Intel386™ EX Embedded Processor

Specification Update

October 1998

Order Number: 272873-010

1. Watchdog Timer (WDT) Bus Monitor Failure During Bus Pipeline Operation

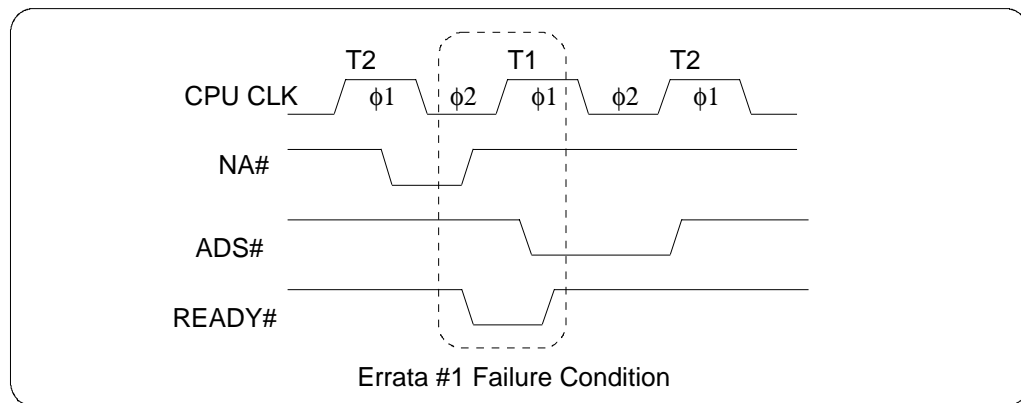
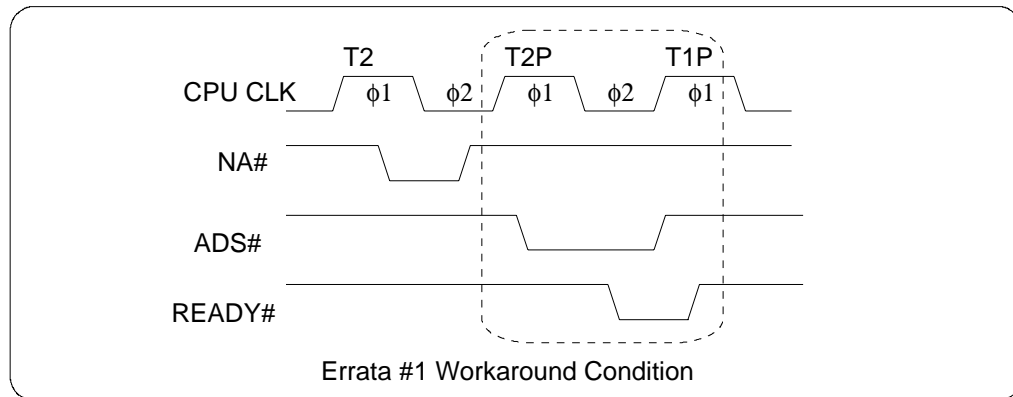
Problem: The errata applies to the WDT unit when using the Bus Monitor Mode and Bus Pipeline operation. If a pipelined bus cycle is requested at the same time the current bus cycle is completed, the WDT down counter is not reloaded or stopped. This condition means that the WDT could time-out and erroneously report a system failure. The waveform below shows the errant condition.

The errata condition is caused by the system generating READY# immediately after NA# has been requested, and a T1 cycle is generated (rather than a T2P cycle). Essentially, the system is requesting a pipelined access, but does not need it because READY# has been returned. Such a condition is not typically expected when using the pipeline feature.

Implication: Applications that use the bus monitor mode of the WDT need to be aware of this condition. If bus pipelining is not used, the errata can be ignored. If bus pipelining is used, look to the workaround description below to ensure the errata condition is avoided.

Workaround: Ensure that READY# is not generated after a pipelined bus operation is requested. See the example waveform below.

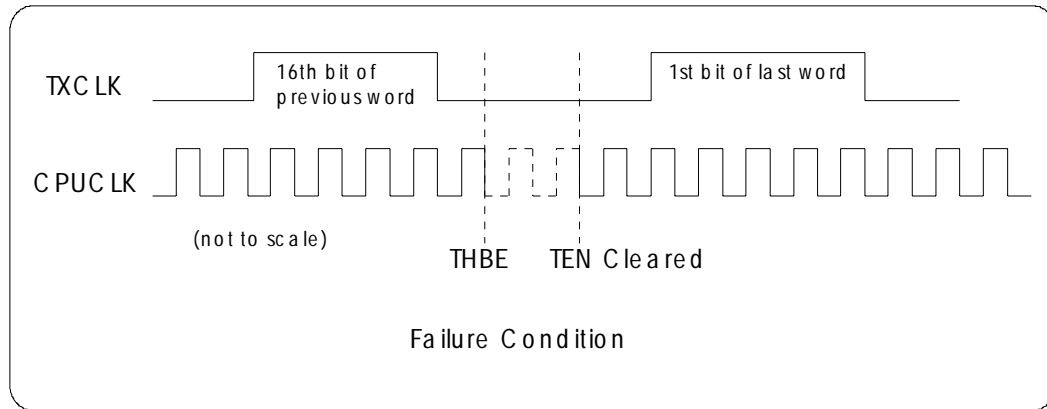
Problem: Between the DMA logic and the DMA state machine is a problem that manifests itself if the bus arbiter changes which channel with an active request has the highest priority, and at the same instant asserts XFRREQ (transfer request). If the bus arbiter receives a DMA request on a channel that has a lower priority, it will activate an enable channel signal to the DMA, and request the bus from the core. If a request comes in on a higher channel, the bus arbiter will then deselect the channel with a lower priority, and select the channel with the higher priority. If conditions are right, the bus arbiter can deselect the lower priority channel, select the higher priority channel, and give the DMA XFRREQ (transfer request) simultaneously.

Implication: This errata applies to all applications that use both DMA channels. This problem appeared specifically when the DMA priority was set to its default value (i.e., DMA0 has higher priority over DMA1).

Workaround: Change the default DMA priority by writing 00h to DMACMD2 register, and always use DMA1 as the higher priority channel.

30. HLDA Inactive To HOLD Active Arbitration Could Improperly Float The Bus

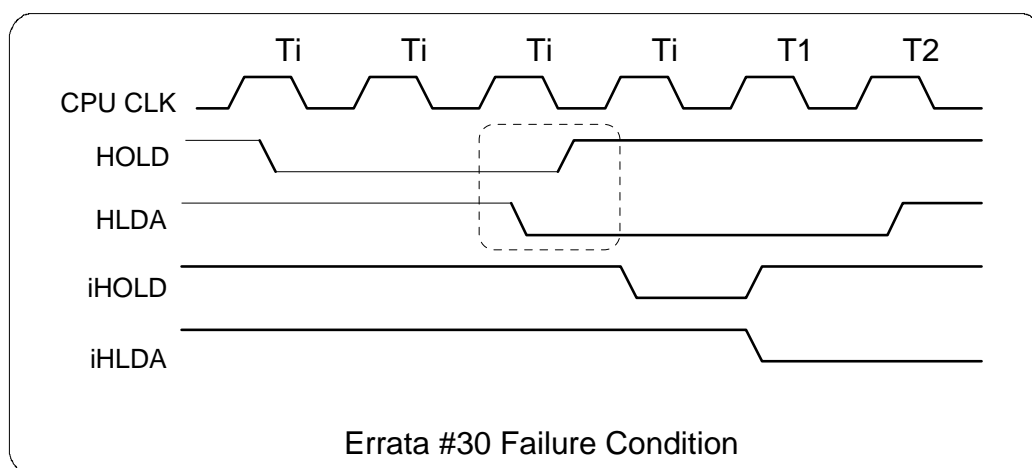
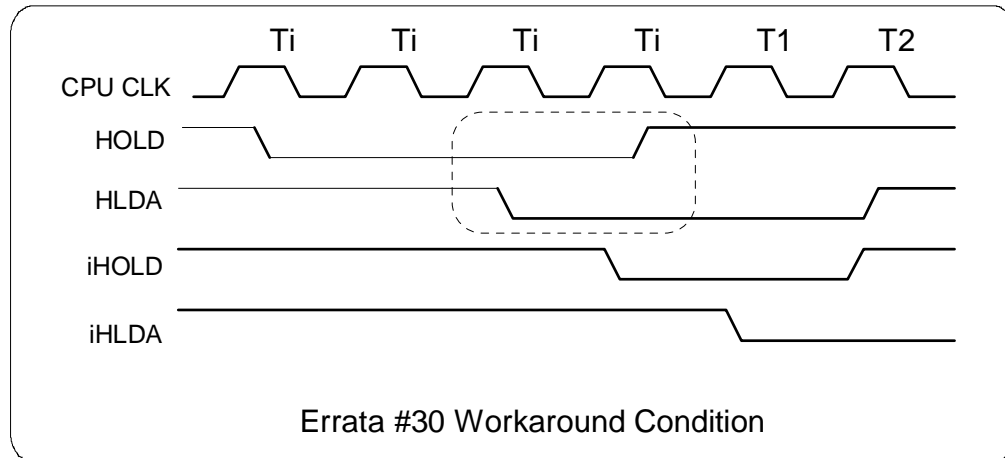
Problem: In a HOLD/HLDA cycle the HOLD signal must not be re-asserted until after HLDA is returned inactive. If, however, HOLD is asserted in the same T-state that HLDA goes inactive a problem may occur where the bus arbiter relinquishes control to the core and at the same time floats the bus by asserting the HLDA pin. The following waveform shows the conditions that cause this error. The signals iHOLD and iHLDA are internal signals and represent the HOLD input to the core and the HLDA output from the core (equivalent to the HOLD and HLDA signals on a Intel386™ SX processor). In this diagram a T1 occurs because a request was pending by the core during the previous HOLD cycle. One T-state after the arbiter releases the bus (HLDA = 0) it removes its iHOLD, and then the core removes iHLDA. As soon as the iHLDA is released, the T1 state starts. However, because of the timing of the next HOLD request, the bus arbiter re-asserts iHOLD and HLDA even though the core has not asserted iHLDA. The result is that the core continues to run its bus cycle and, at the same time, the bus arbiter has floated the external bus. It is also possible for the following to occur when HOLD/HLDA arbitration is at issue: HOLD is driven active during the T1 or Tw of a valid bus cycle. The processor begins the next bus cycle and generates HLDA. HLDA is active for only one T-state. ADS# is extended through the bus cycle. The alternate bus master sees the HLDA and performs its bus activity. HOLD is then driven inactive and the bus is returned to the Intel386™ EX Processor. At this point there is bus contention.

It is also possible for the following to occur when HOLD/HLDA arbitration is an issue: HOLD is driven active during the T1 or Tw of a valid bus cycle. The processor begins the next bus cycle and generates HLDA. HLDA is active for only one T-state. ADS# is extended through the bus cycle. The alternate bus master sees the HLDA and performs its bus activity. HOLD is then driven inactive and the bus is returned to the Intel386™ EX Processor. At this point there is bus contention.

- Implication:** This errata applies to all applications that use external bus masters with HOLD/HLDA arbitration.
- Workaround:** Synchronize the external HOLD request such that it does not go active until at least one T-state after HLDA is inactive. See the following example waveform.

Another workaround is to delay the generation of HOLD until the last T2-state of a valid bus cycle (excluding refresh cycles or INTA cycles).

Figure 3. HOLD with Short REFRESH Interval

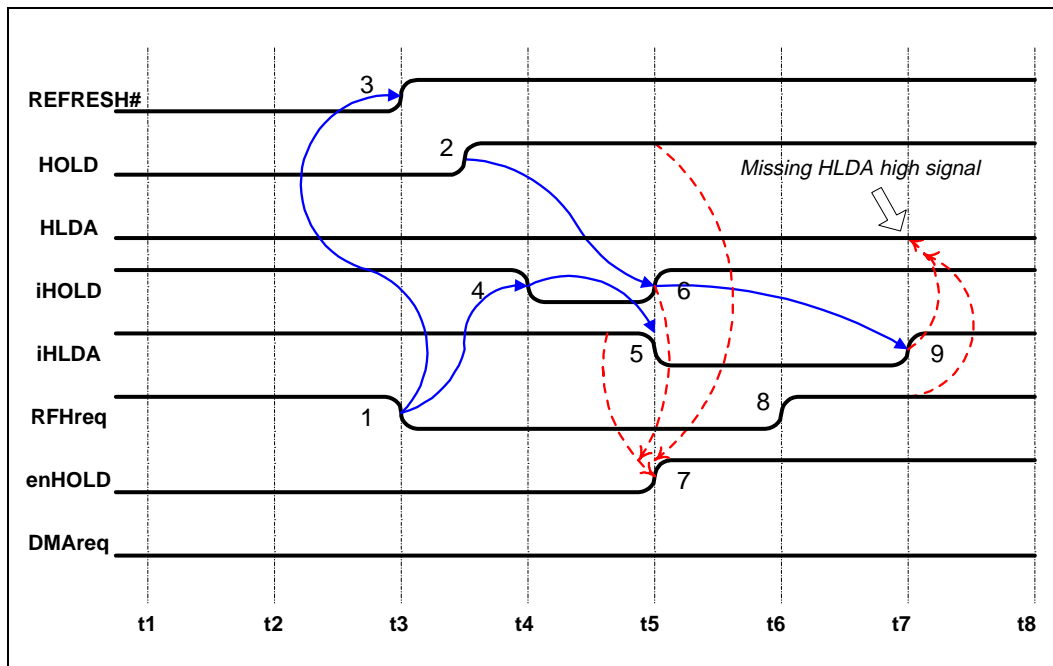
Figure 3 shows Condition #1a where an external HOLD and refresh request conflict can occur. The table below describes each signal name used:

Figure 4. Quick HOLD Assert and Deassert with Slow REFRESH Interval

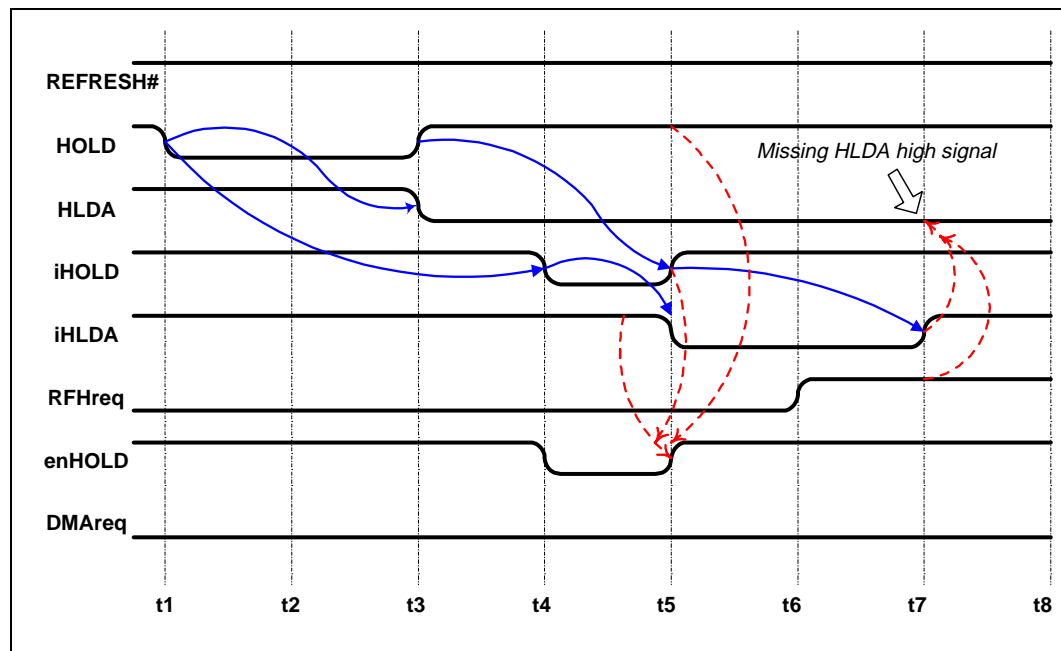
- b. HOLD is removed and reasserted within one bus cycle. Refer to Figure 4. This condition will cause the problematic window with fast iHOLD deassertion (t4) and assertion (t5). Note that if HOLD is deasserted because of pending REFRESH and reasserted again within one bus cycle, the problem will not occur since the iHOLD signal is never deasserted due to refresh. The reassertion of the HOLD would then be serviced upon completion of the refresh.

Figure 5. DMA, HOLD and REFRESH with Normal Interval

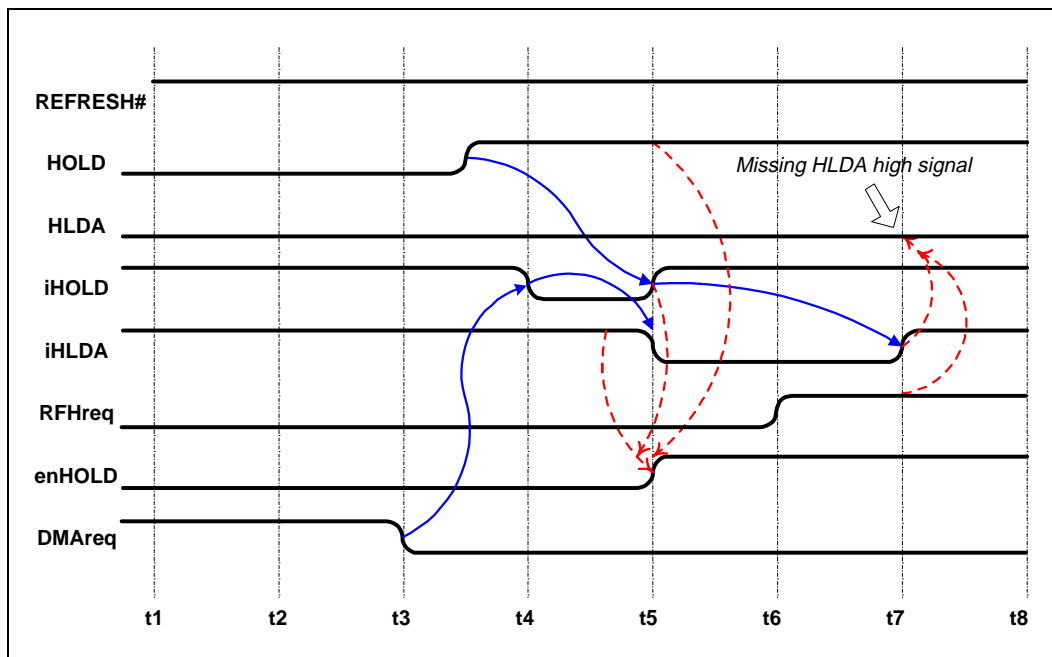
For the errata to occur, HOLD must be asserted asynchronously at any cycle such as in an idle cycle. Refer to Figure 5. Termination of DMAREQ at time t3 with assertion of HOLD at time t4 creates the problematic window. If there is a refresh request at time t6, the HLDA is blocked and will not go active at time t7. If HOLD is synchronized at the beginning of a new valid bus cycle (except for REFRESH), HLDA will always be asserted since the problematic window will not occur.

Note: DMAREQ is a signal internal to the processor. This signal is not always within the user’s control and could be internally deasserted, such as in autoinitialize mode. To avoid issues with this type of situation, it is recommended that the user deassert the external request DREQ after the last transfer has completed. It is further recommended that DREQ only be deasserted after a valid DMA acknowledge (DACK# goes low) has been returned. If a DREQ is held active and then deasserted during or shortly after the autoinitialize sequence, the problematic window can be induced and cause the errata to occur. See errata #28 for additional details on DMA programming restrictions.

Figure 6. Two DMA Channels in Cascade Mode with Internal RCU Anomaly

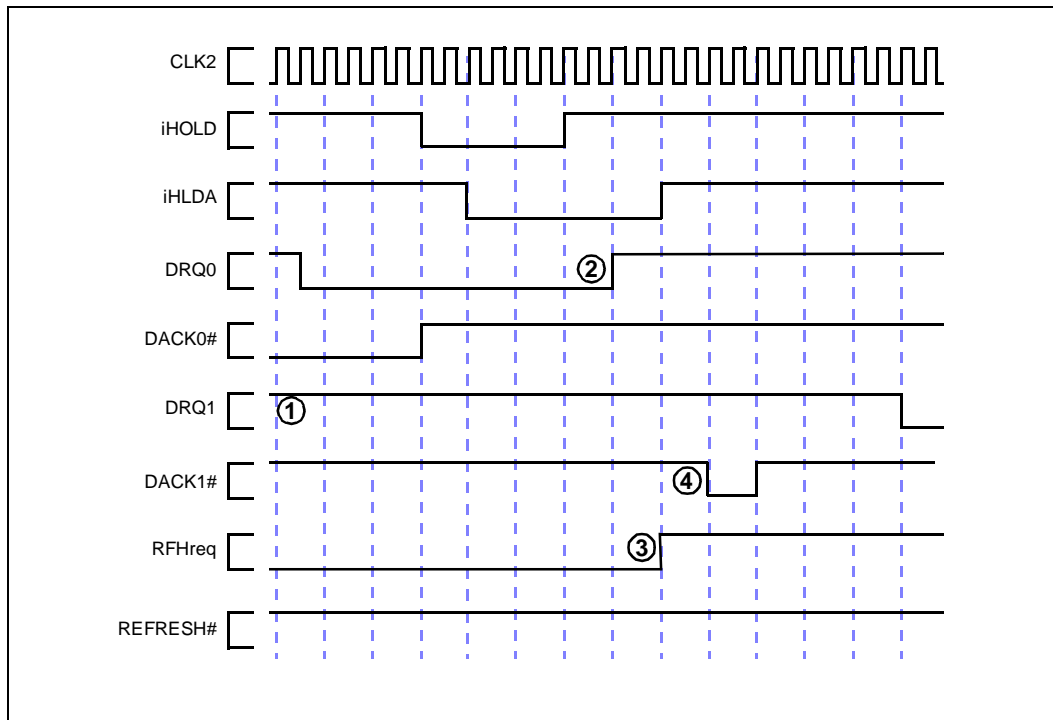
This anomaly is shown in [Figure 6](#) (internal signals used in the diagram are described in the table below). Both DMA channels are in cascade mode and Channel 1 is programmed to have the lowest priority.

The lower priority DMA channel requests the bus by asserting DRQ1 (see 1 in Figure 6). The higher priority channel requests the bus by asserting DRQ0 before the iHLDA has returned from the core (see 2 in Figure 6).

While the Bus Arbiter Unit is in the process of arbitrating priorities between the DMA channels, an internal refresh request signal (RFHreq) is asserted (see 3 in Figure 6) one PH1 cycle before the DMA acknowledge is granted (DACK1# asserted - see 4 in Figure 6). This scenario confuses the bus arbiter and the DMA acknowledge is given to the *lower* priority DMA channel. The arbiter believes the acknowledge was granted to the *higher* priority channel. The DACK1# is quickly taken away from the lower priority channel due to a pending refresh request. DMA channel 1 drops its request, apparently releasing the bus for a REFRESH cycle, but the arbiter is waiting for the higher priority channel to drop its request (DRQ0); this never occurs, since the acknowledge was never granted (DACK0#), and the system hangs.

10. 272485-002, Section 6.3.6, Page 6-29, Figure 6-11.

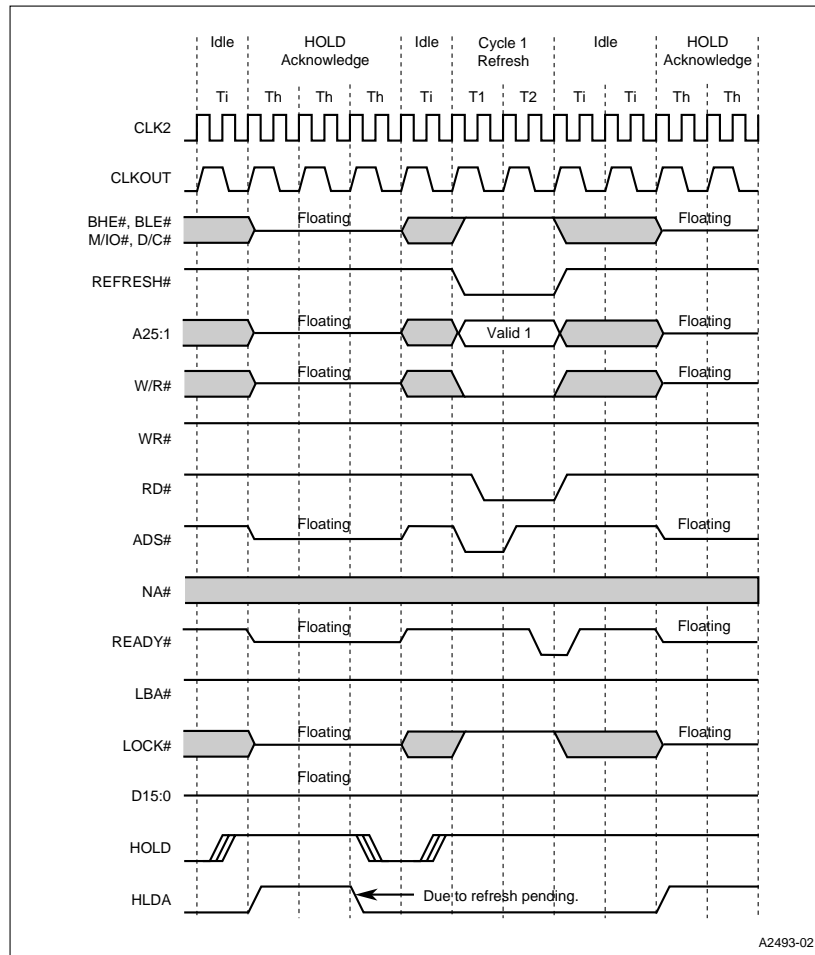
Issue: Changed “BHE#, BLE#, M/IO#, D/C#” to read “UCS#, CS6:0, BHE#, BLE#, M/IO#, D/C#”.

Figure 12. Transmit Data by Polling

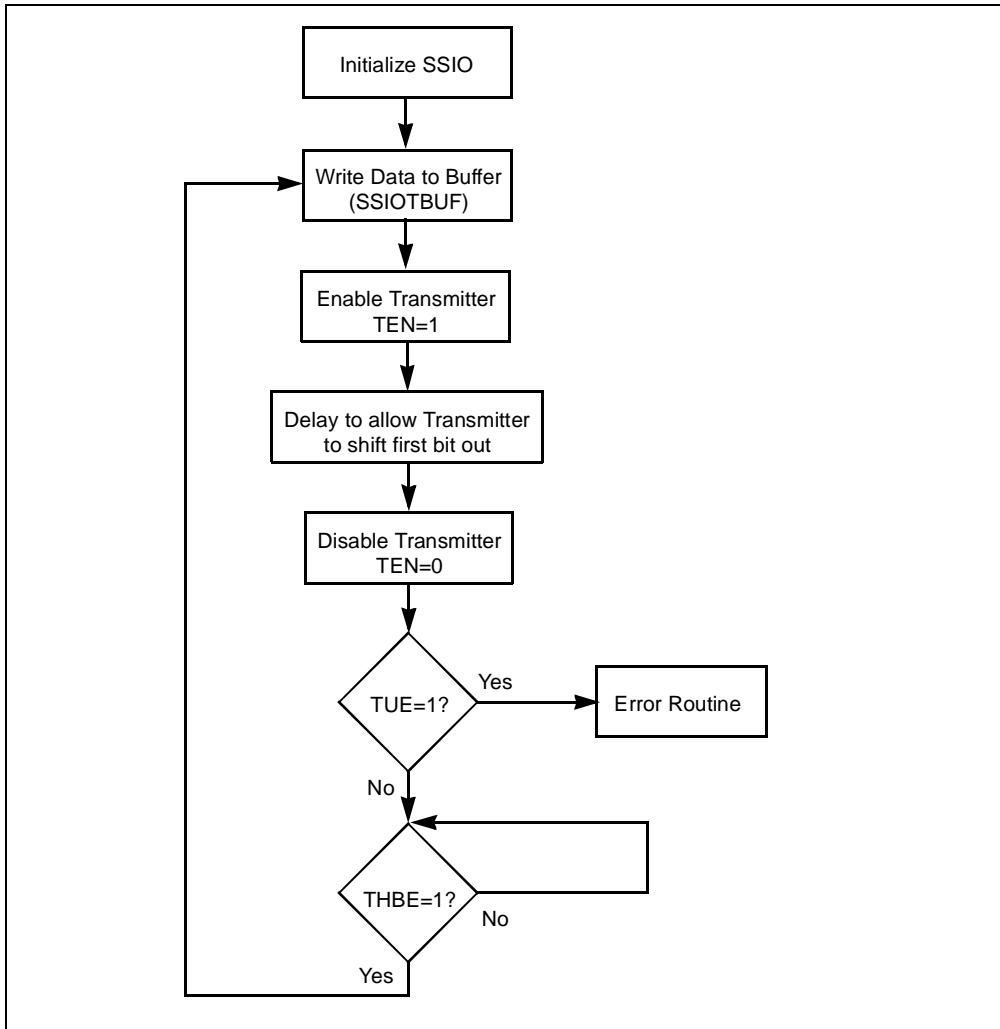
Issue: Replace figure 13-8 with Figures 13-8a and 13-8b as shown below.
